CLIENT: An Bord Pleanála

PROJECT: Slane Bypass Noise IA Review

Prepared by: AONA Environmental Consulting Ltd.

Date: June 2024

Figure 1: Baseline noise survey locations at 24-4-A and 24-4-B and noise impact prediction locations at R1320 and R1321 [Google Earth Imagery].

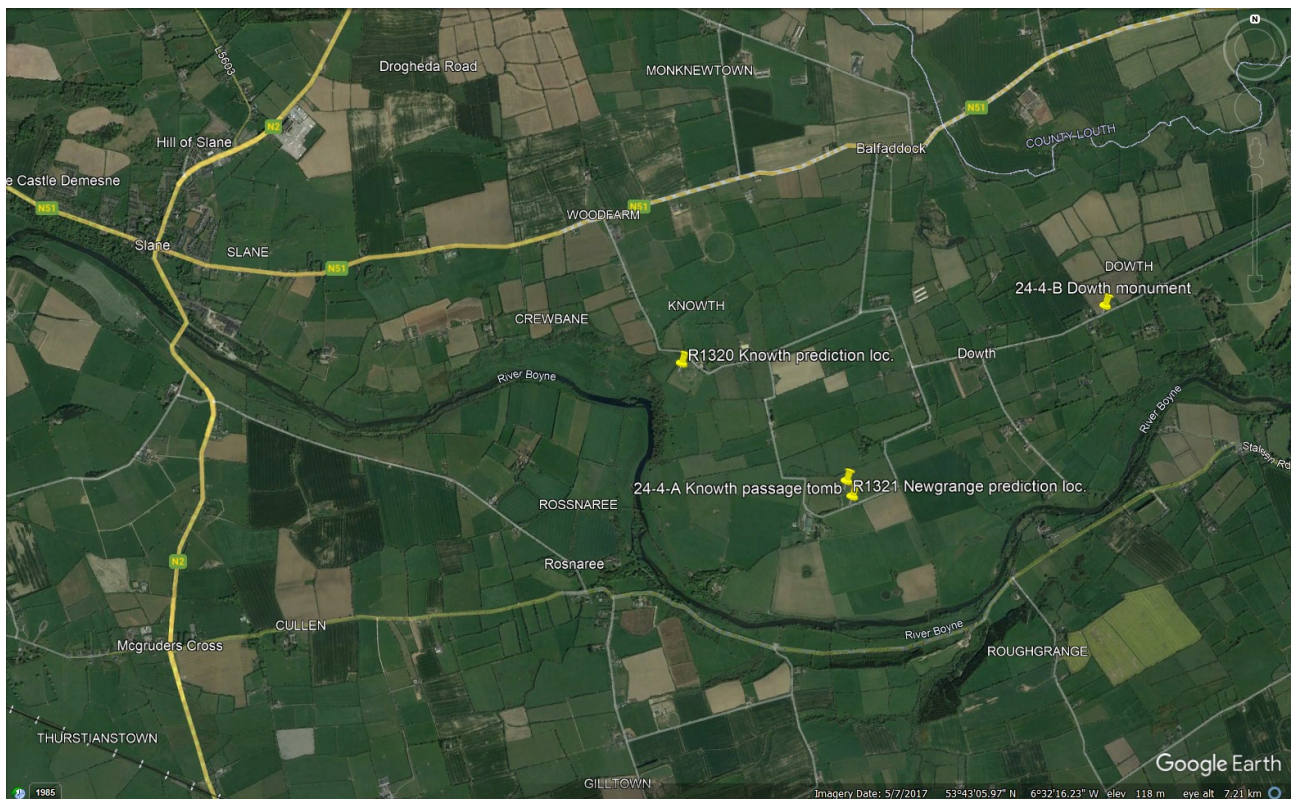
The measured baseline noise levels quoted in Table 1 are relatively quiet daytime noise levels and typical of such a rural area located in excess of four kilometers from the main traffic routes in the area, i.e. the N2 and N51. The reported baseline noise levels of <40 dB L_{A90} at

24-4-A and 24-4-B indicate that traffic noise is not at a level that could be construed to have a significant impact at the protected monument sites.

In terms of operational noise impact, Appendix 9.2, Receptor Locations outlines the traffic noise prediction locations entered in the model at R1320 'Knowth' (Grid Ref. 699552, 773456) and R1321 'Newgrange' (Grid Ref. 700630, 772723). The locations of R1320 'Knowth' and R1321 'Newgrange' are shown in Figure 1.

The predicted noise levels quoted in Table 2 indicate no significant change in noise level at the Brú na Bóinne UNESCO World Heritage Property and the predicted traffic noise is not at a level that could be construed to have a significant impact at the protected monument sites.

In the Opening Year (2026) there will be a predicted +1 dB(A) increase in noise levels and in the Design Year (2041) there will be no predicted increase in noise levels at the Brú na Bóinne UNESCO World Heritage Property. Therefore, there will be no discernible change in traffic noise level due to the proposed scheme.
